A D D E N D U M

Project No.: 2501101
Project: EACS Restroom Renovations

Addendum No: 02
Date: 04/02/2025

ADDENDUM NO. 02, to Drawings and Specifications dated 03/12/2025, for the EACS Restroom Renovations for the East Allen County Schools; as prepared by ELEVATUS Architecture, 111 E. Wayne Street, Suite 555, Fort Wayne, IN 46802

First Floor Electrical Plan

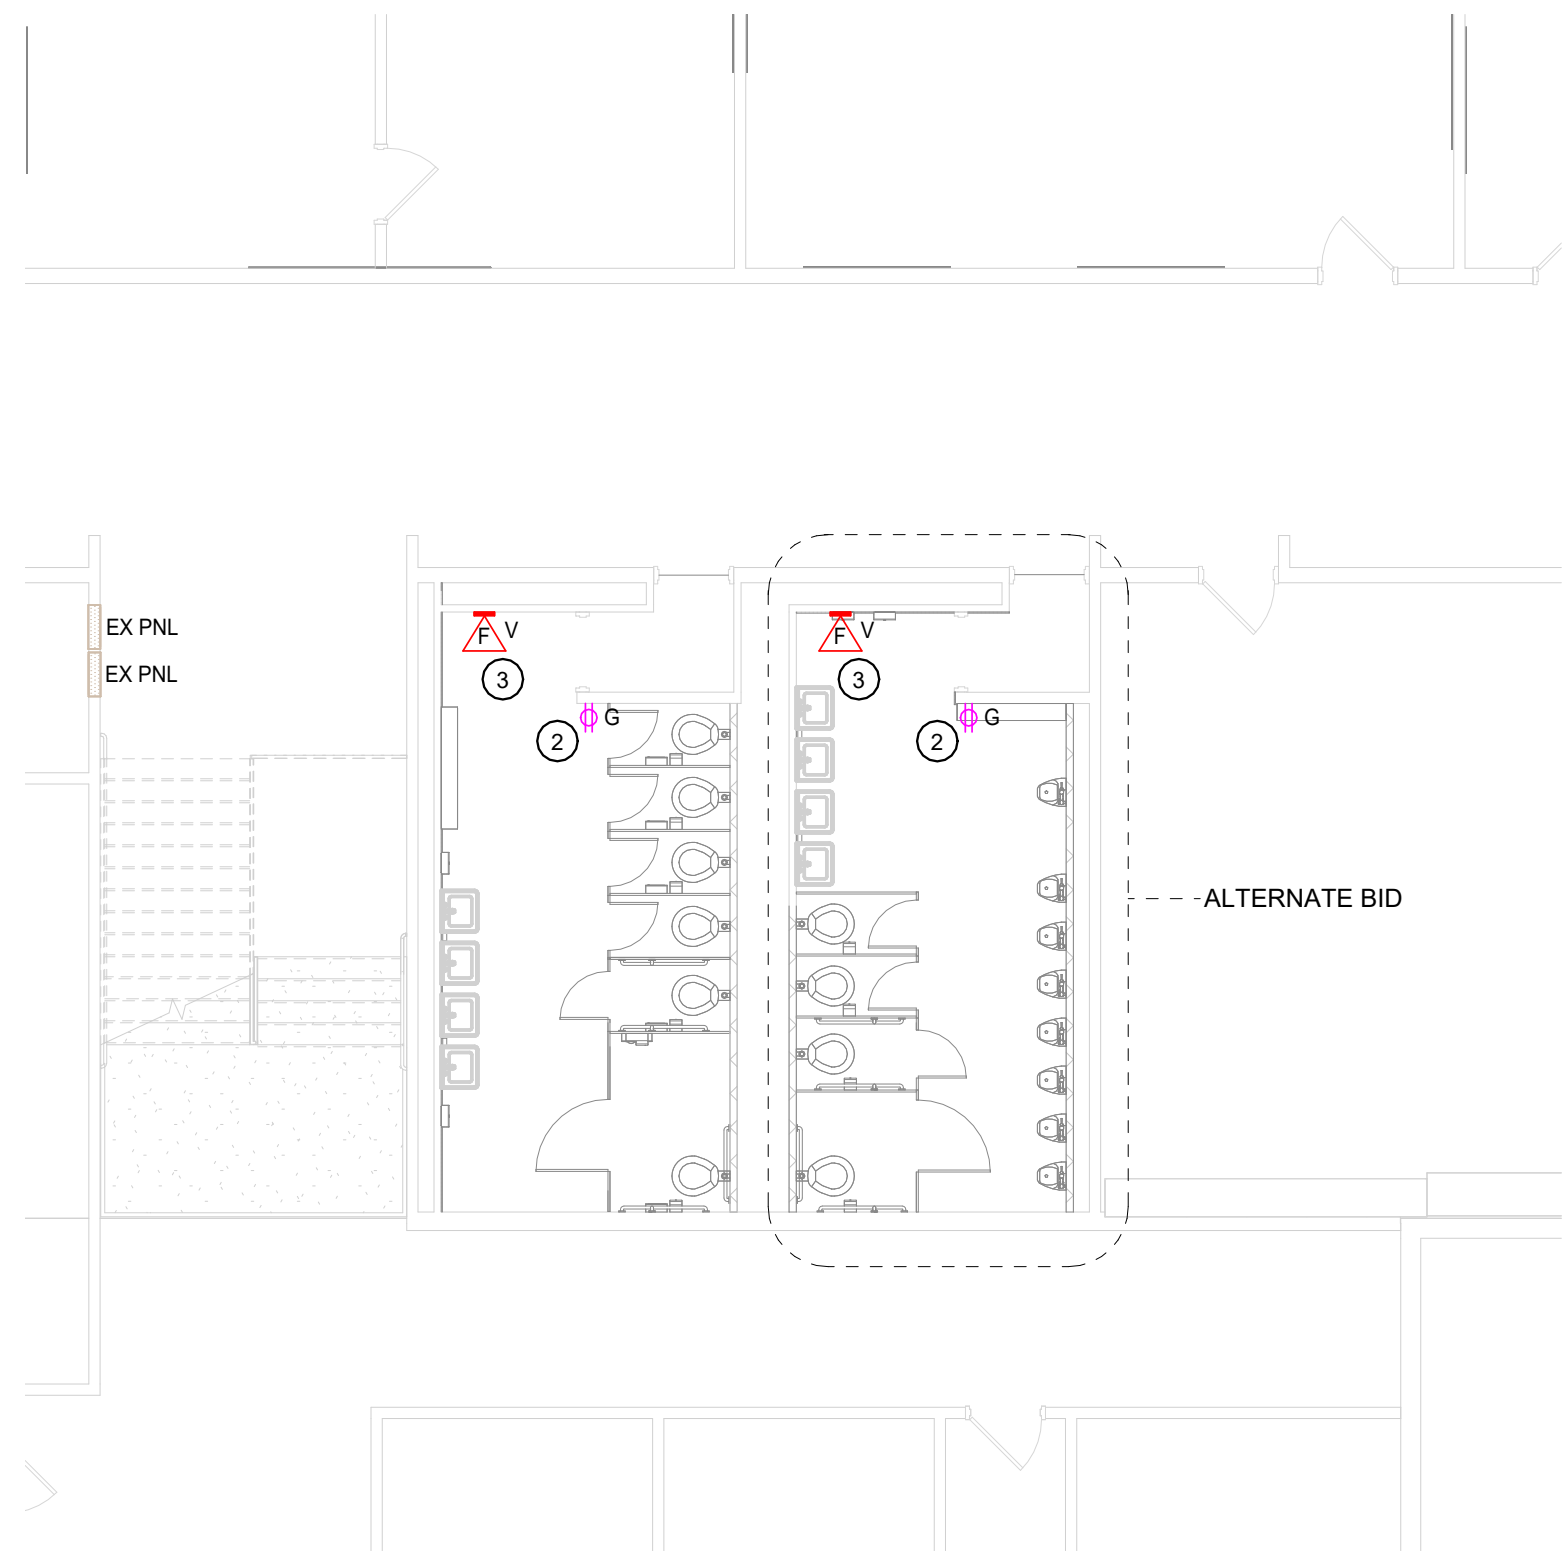
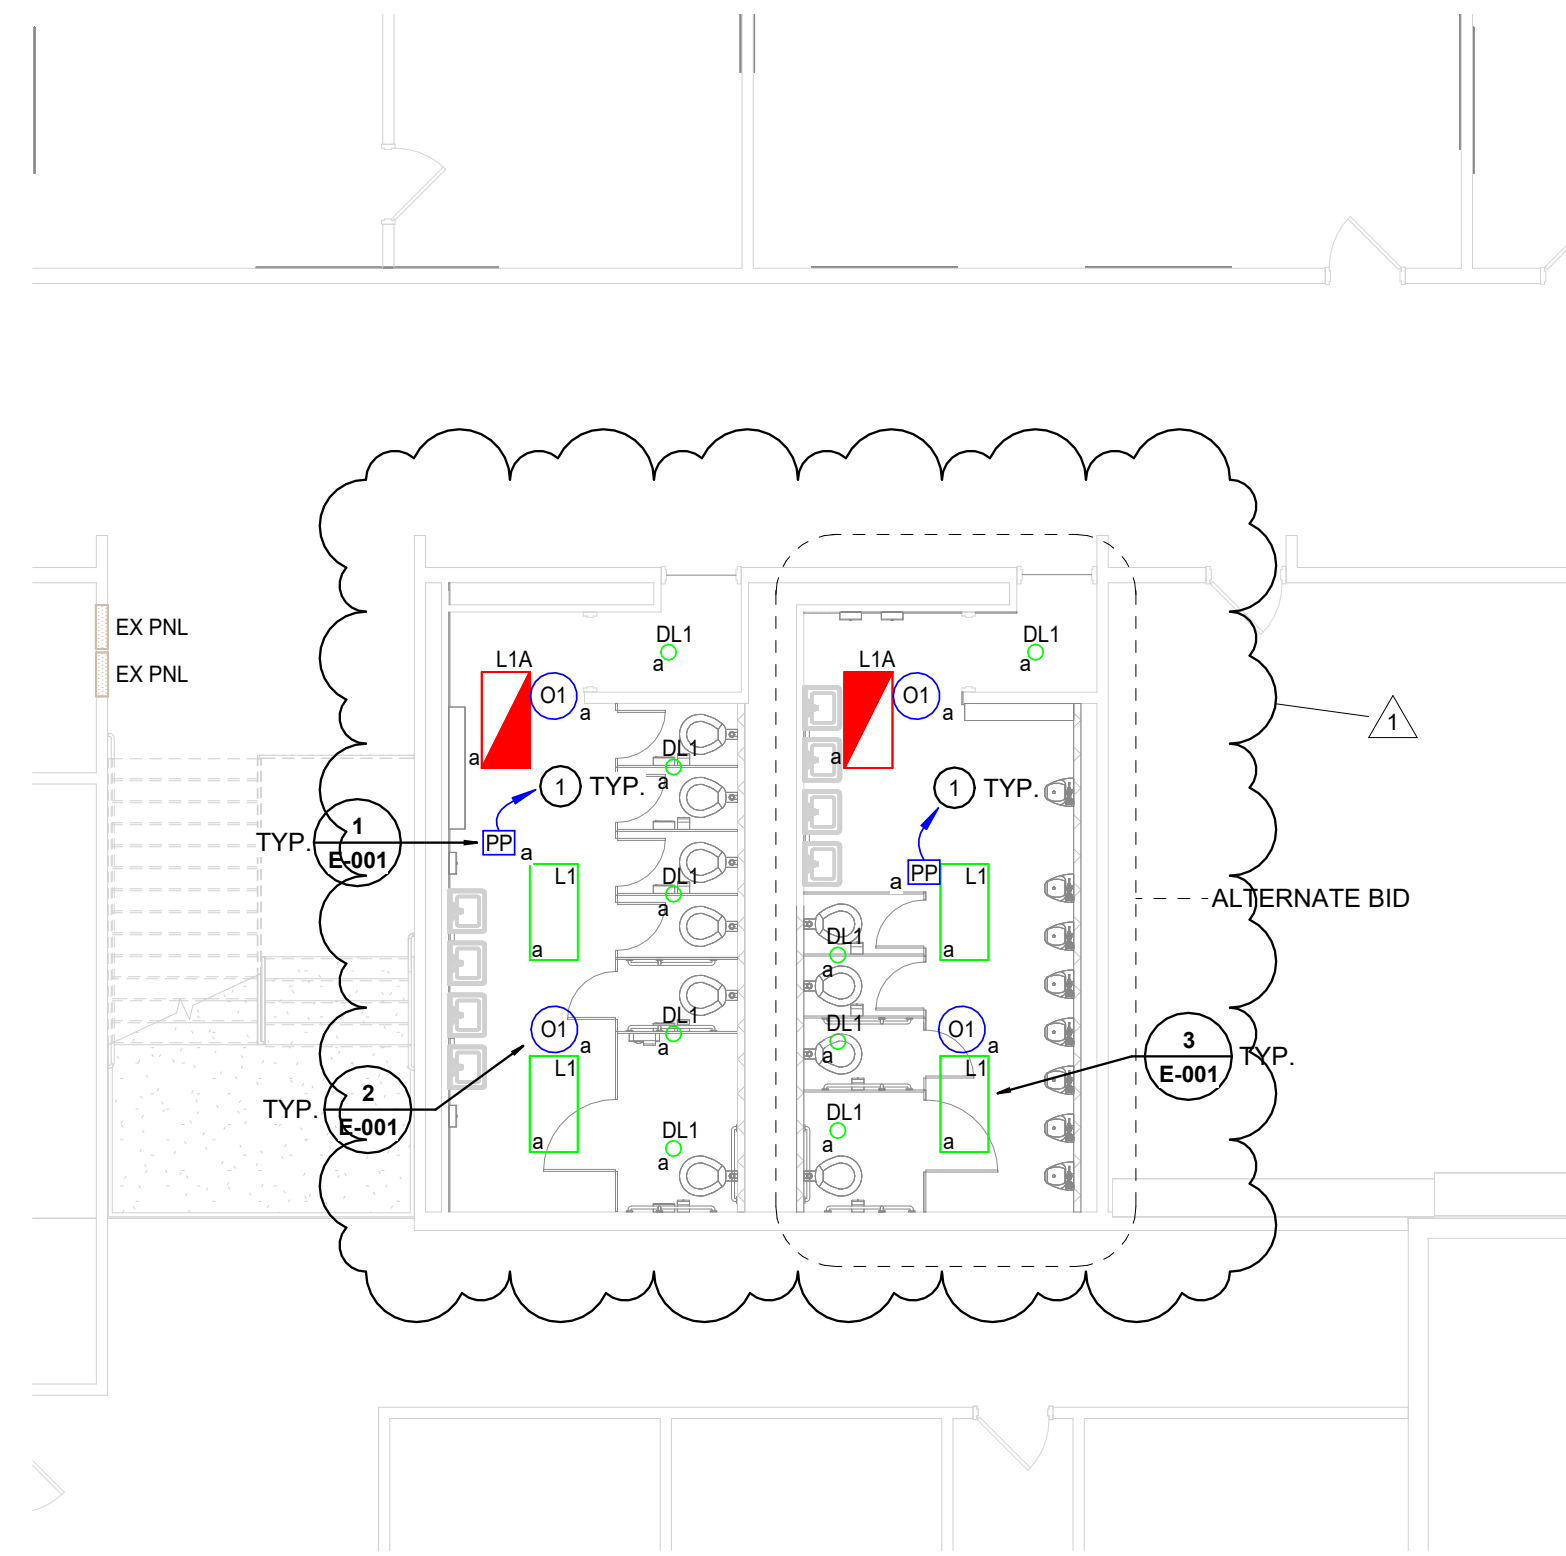
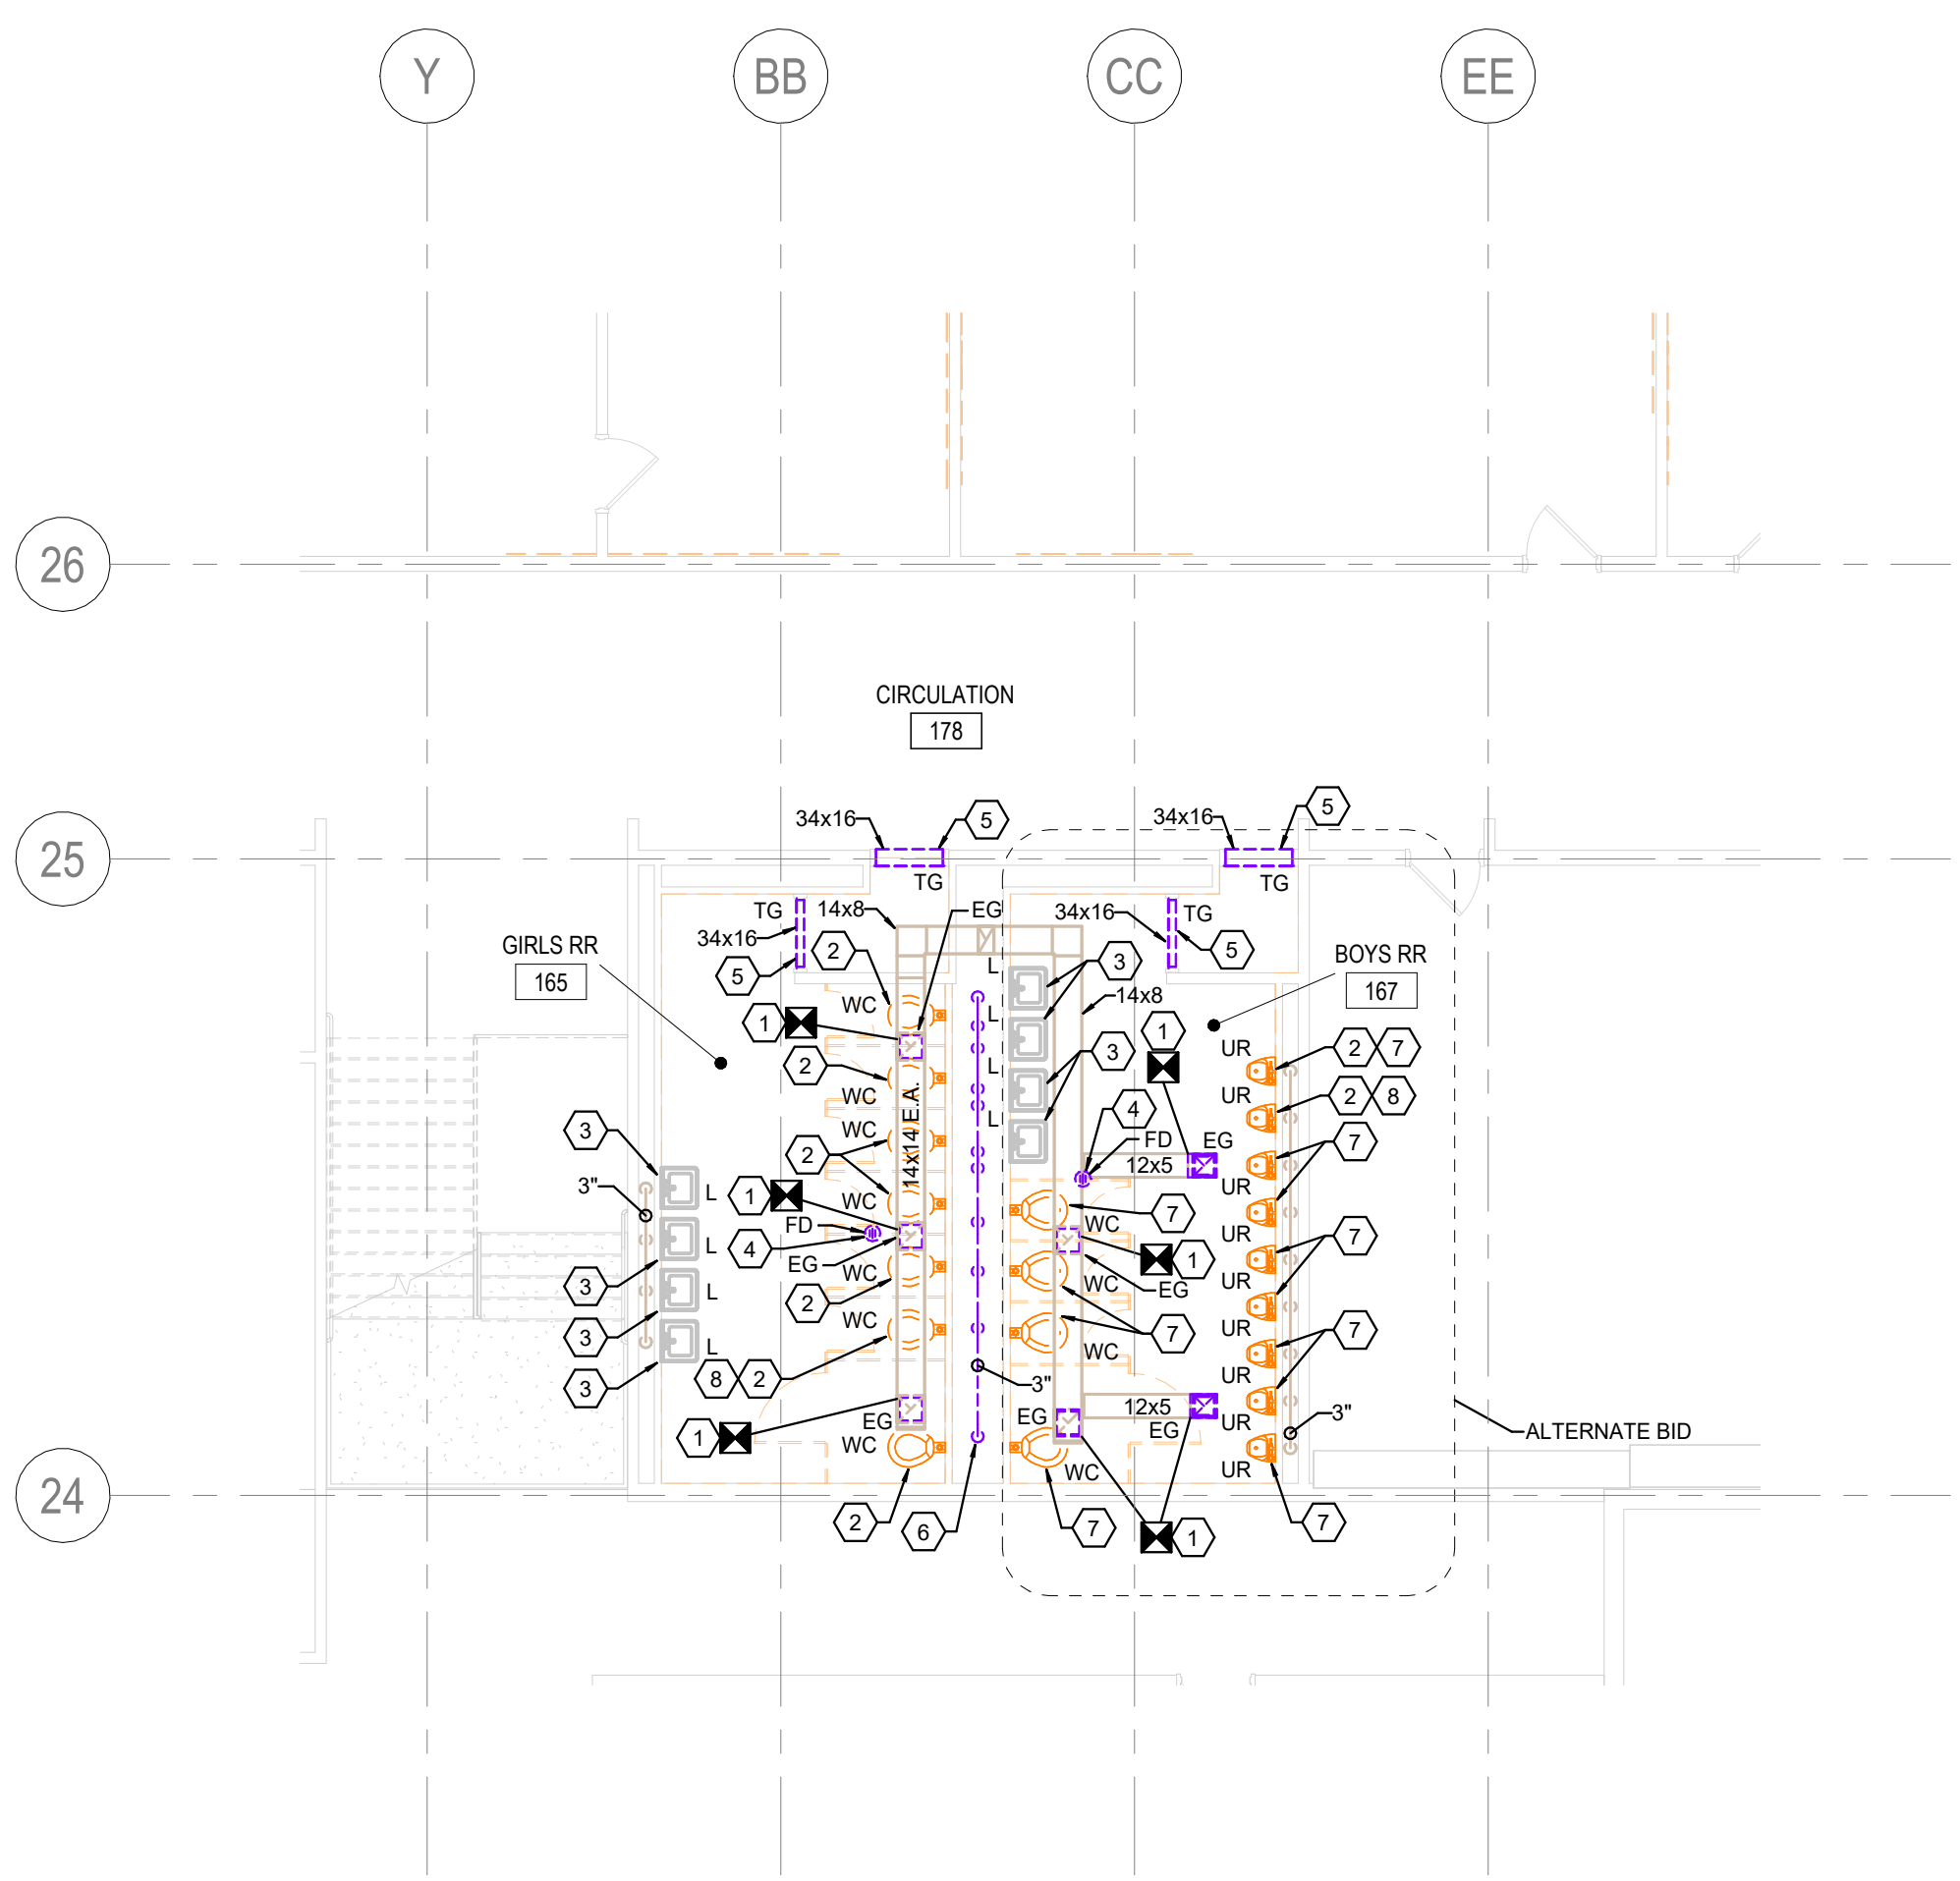
Item #2: Heritage HS: Drawing Sheet E201, "First Floor Electrical Plan":

- A. Revised lighting layout to accommodate for shift in toilet partitions. Refer to drawing sheet E201 labeled Addendum #2 for more information.**
